U.S. NUCLEAR REGULATORY COMMISSION REGION I  
OPERATOR LICENSING EXAMINATION REPORT

EXAMINATION REPORT NO. 50-309/88-02(OL)  
FACILITY DOCKET NO. 50-309  
FACILITY LICENSE NO. DPR-36  
LICENSEE: Maine Yankee Atomic Power Company  
83 Edison Drive  
Augusta, Maine 04336  
FACILITY: Maine Yankee  
EXAMINATION DATES: February 11, 1988

1. SRO Written Examination and Answer Key
2. Facility Comments on Written Examination
3. NRC Resolution to Facility Comments

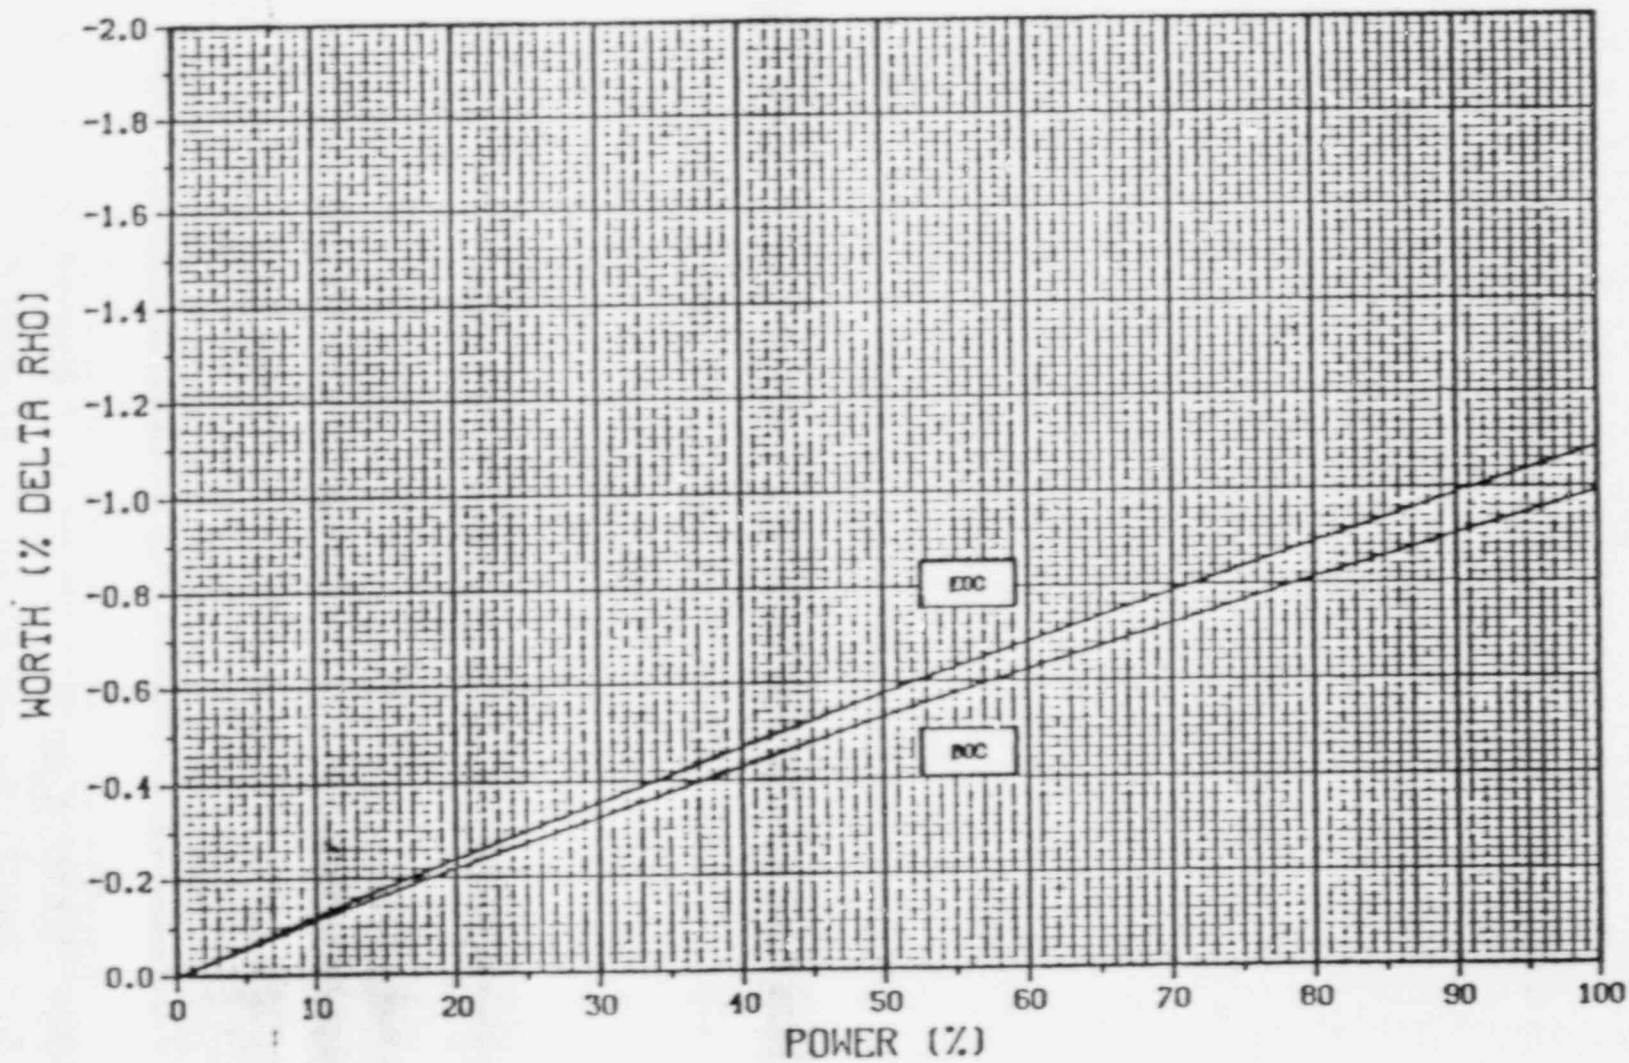
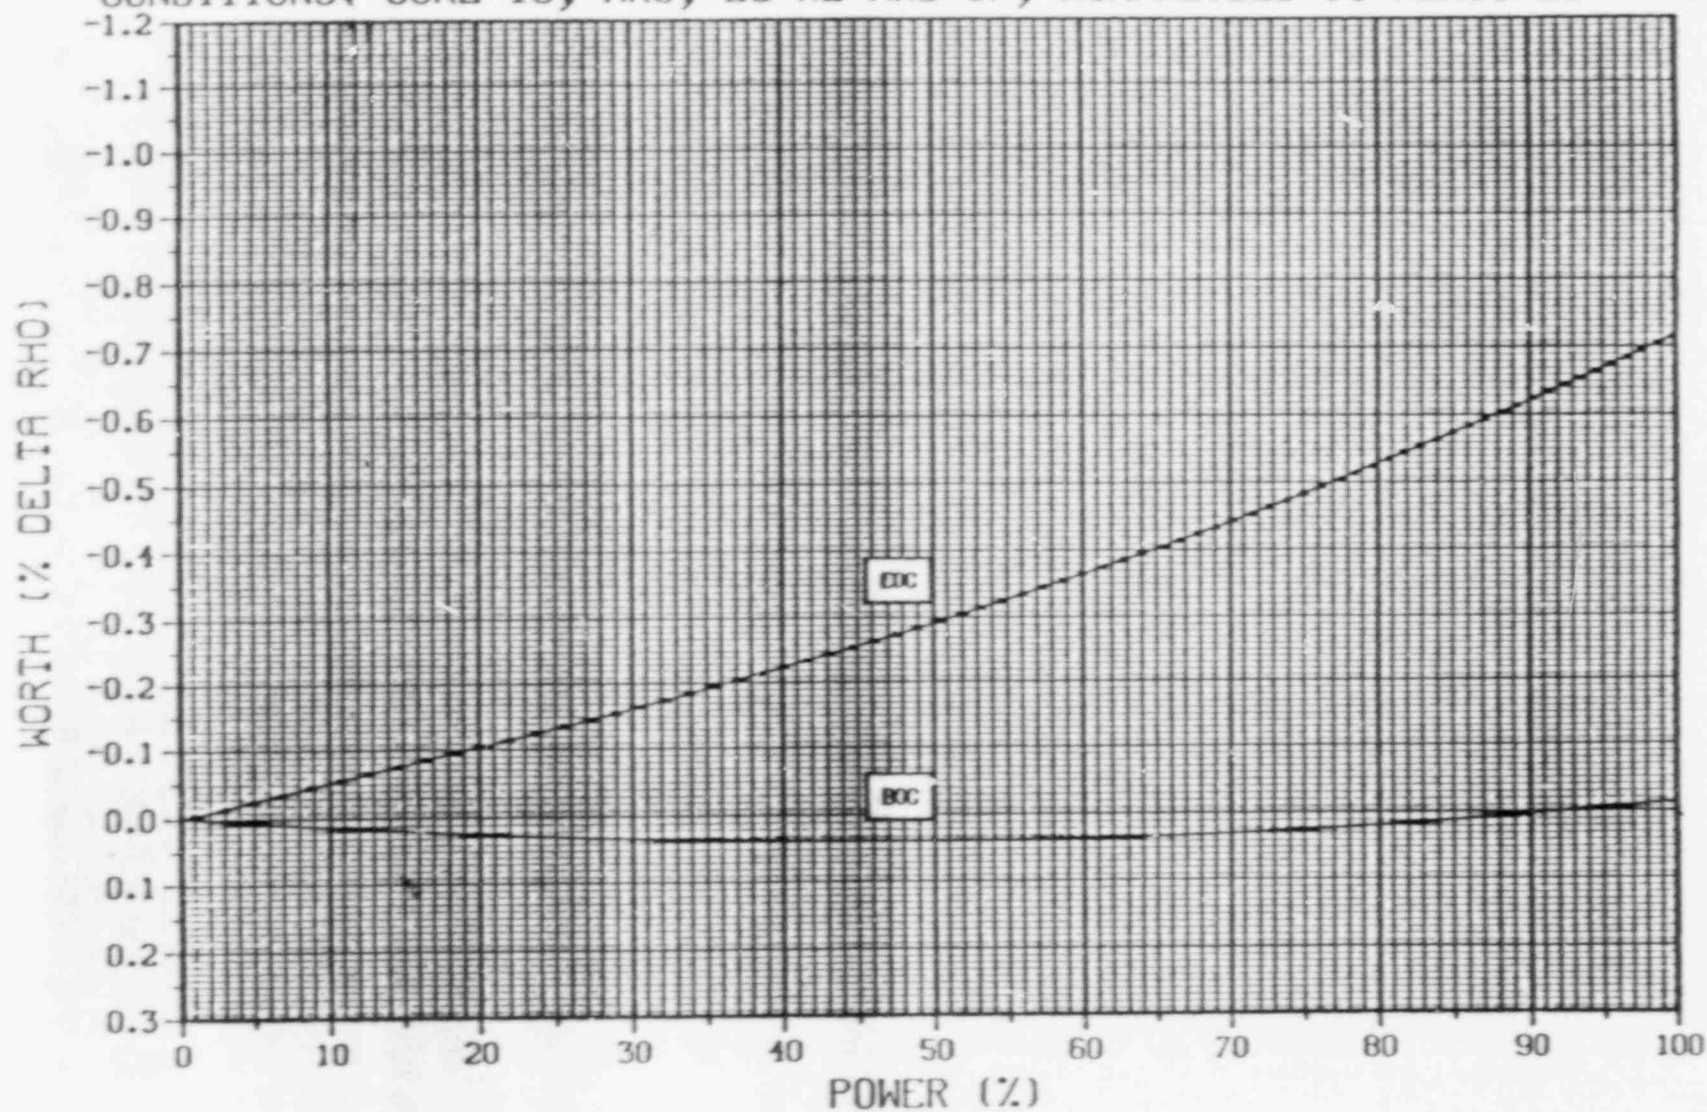
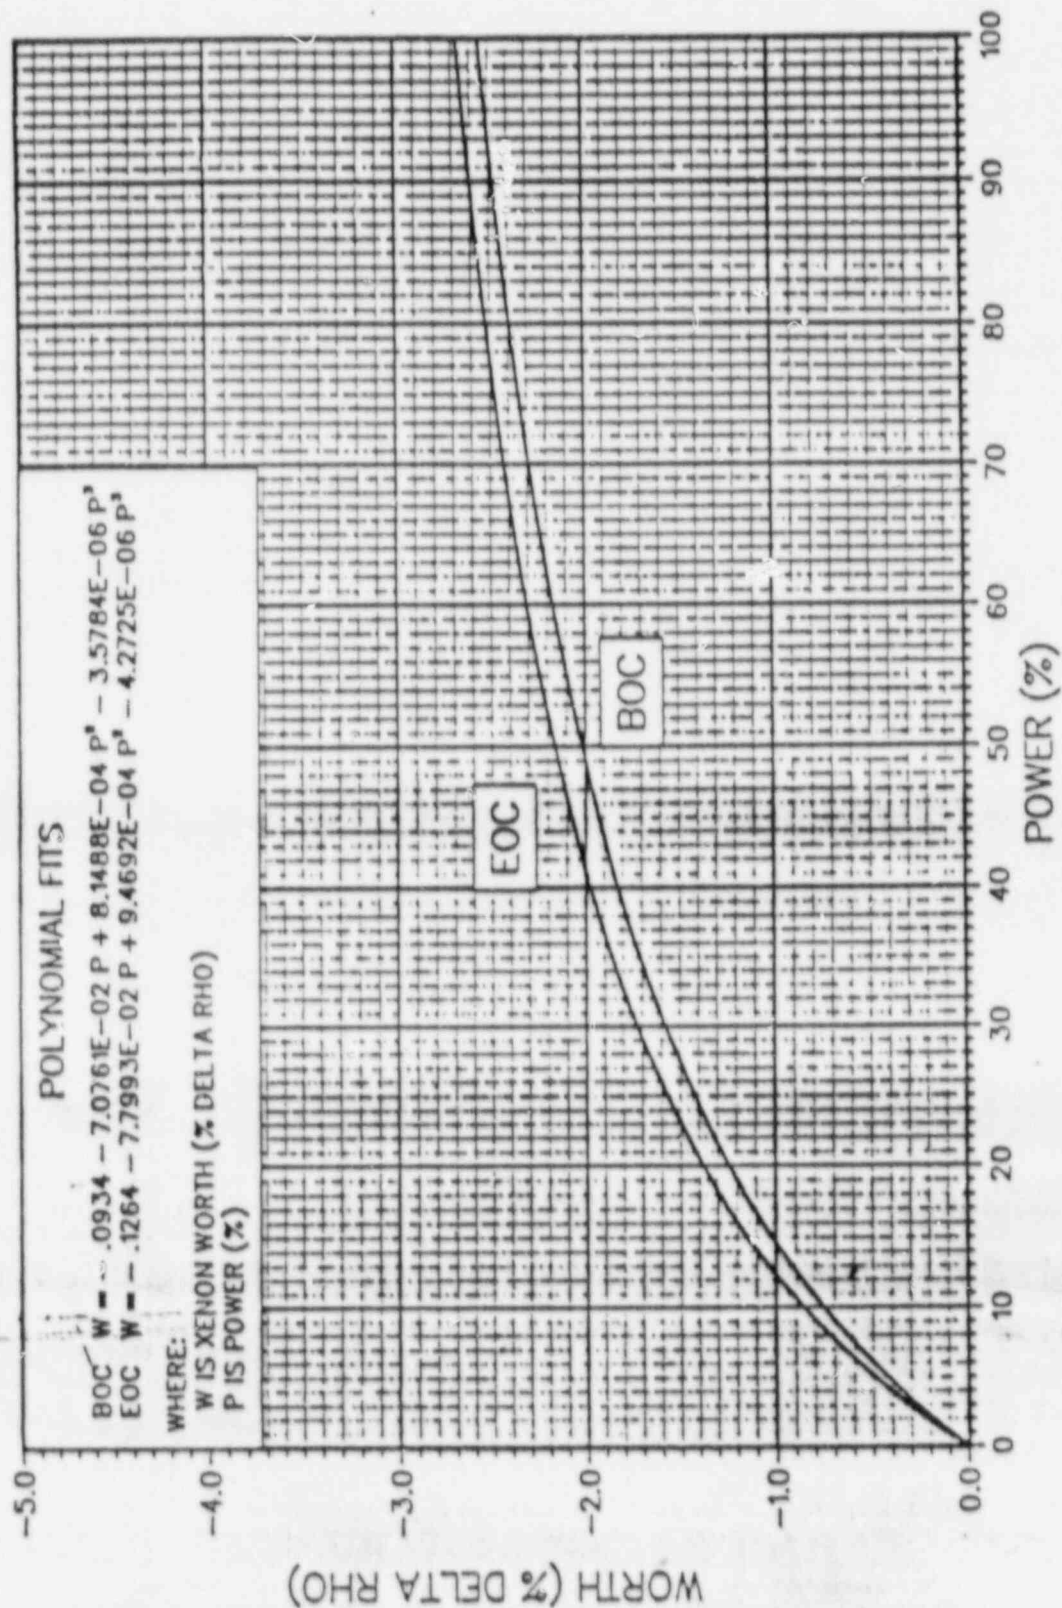
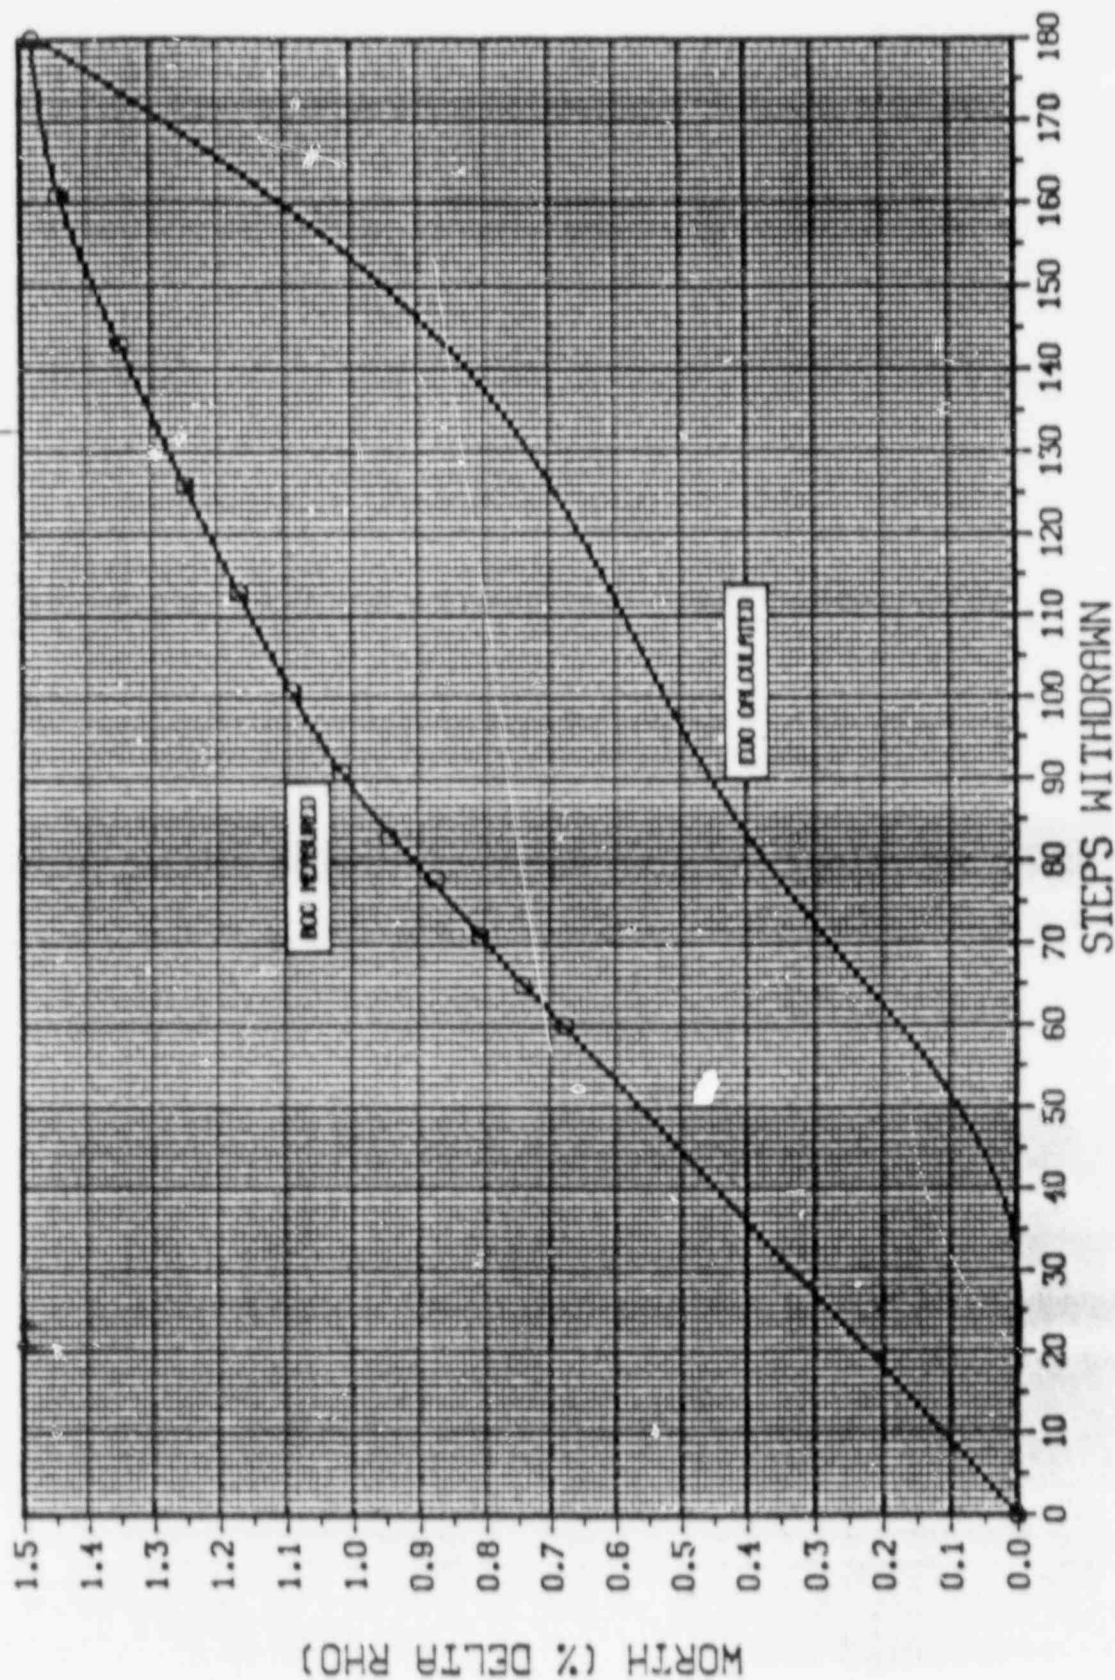
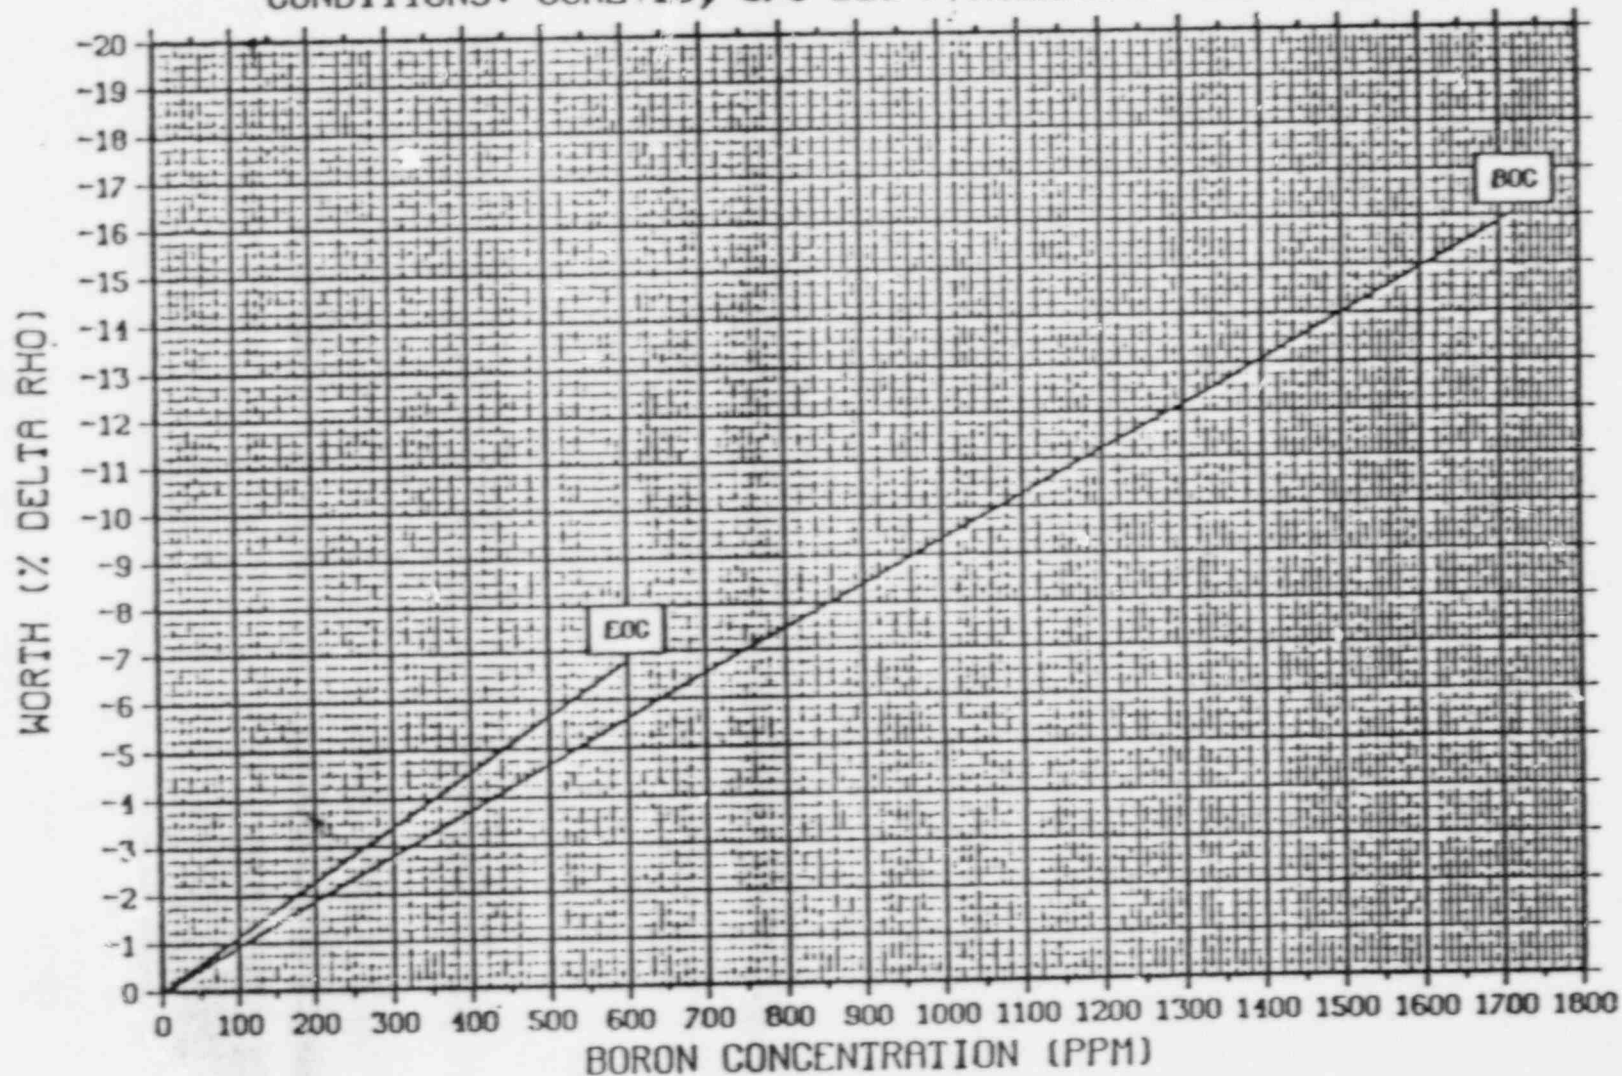
- 5.07 Answering this question requires reading multiple T.D.B. curves accurately. The answer key should reflect a range of acceptable answers based on a reasonable expectation of accuracy when reading these curves.
